**From:** "Galecki, Gregg" <GGalecki@archcoal.com>  
**To:** <ogmcoal@utah.gov>  
**Date:** 3/17/2008 11:45 AM  
**Subject:** Abandoned Equipment - Skyline Mine  
**Attachments:** SCAN 3 13 08 PGS 1-5.pdf; Plate 2.5.pdf

RE: Equipment Abandonment in Coal Lease UTU-67939 of the North Lease area, Canyon Fuel Company, LLC, Skyline Mine, C/007/005.

Title: Abandoned Equipment

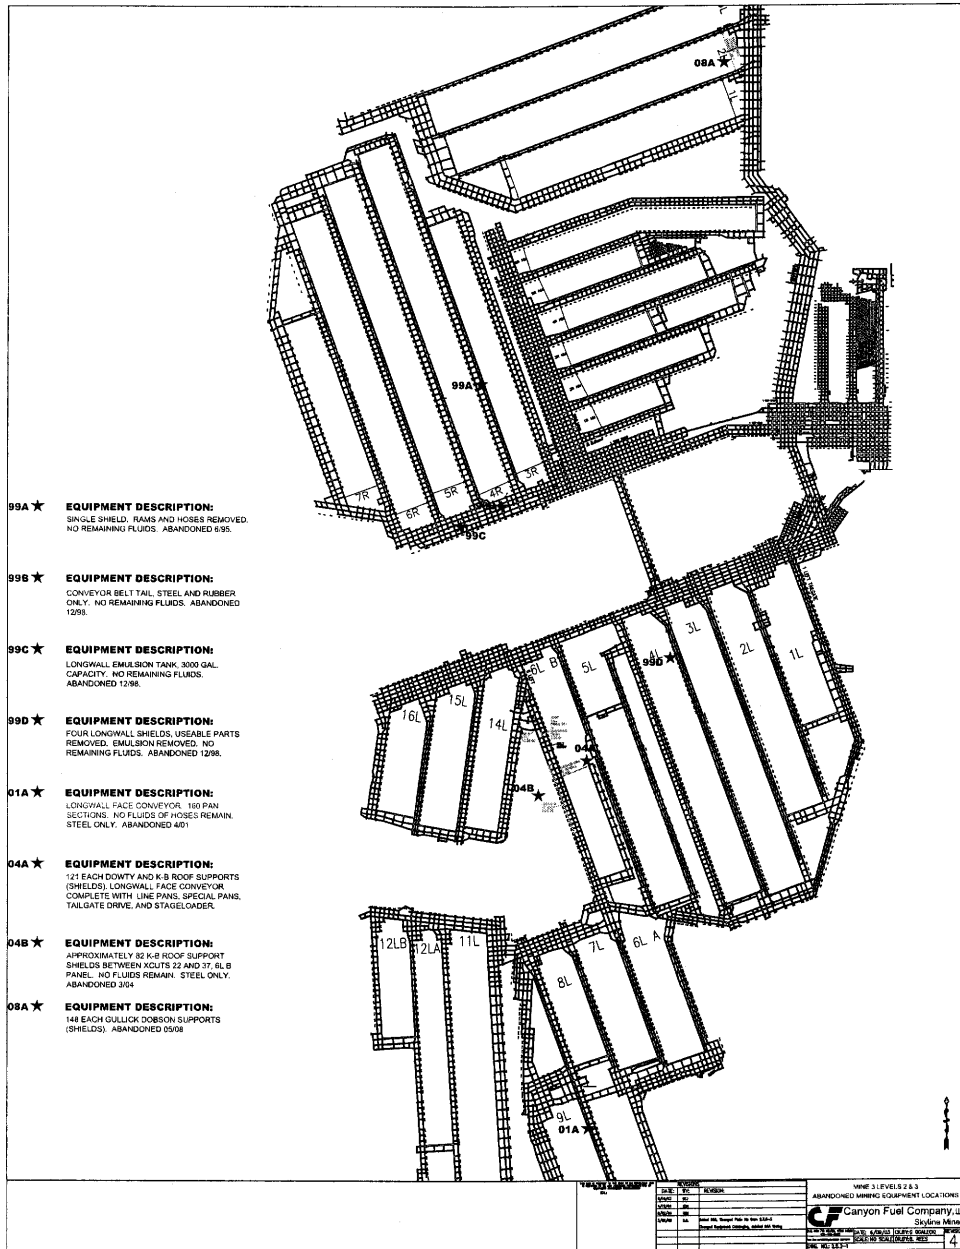
Section 2.5.2 - Hydrological Impacts of Mining located in the currently M&RP addresses the abandonment of equipment. Plate 2.5.2-1 - Abandoned Mining Equipment Locations (formerly mis-labelled as 2.3.6-3) has been modified to include the equipment currently proposed for abandonment. A copy of the map will also be included in the 2008 Annual report.

Please find enclosed with this letter, modifications to the M&RP which include: 1) Plate 2.5.2-1 Abandoned Mining Equipment Locations (formerly Plate 2.3.6-3; and 2) Page 2.51c of Section 2.5 of the M&RP renaming the Abandoned Mining Equipment Locations plate.

Periodically, due to difficult recovery conditions or roof collapse, mining equipment is abandoned underground. Prior to leaving equipment underground, hazardous materials and lubricating fluids are drained when possible. Since the equipment is steel and not too different compositionally from the roof support throughout the mine, contamination to ground water from abandoned equipment is not anticipated. A map illustrating the location of equipment left underground is provided as Drawing 2.5 2-1. The drawing includes a description of each piece of equipment.
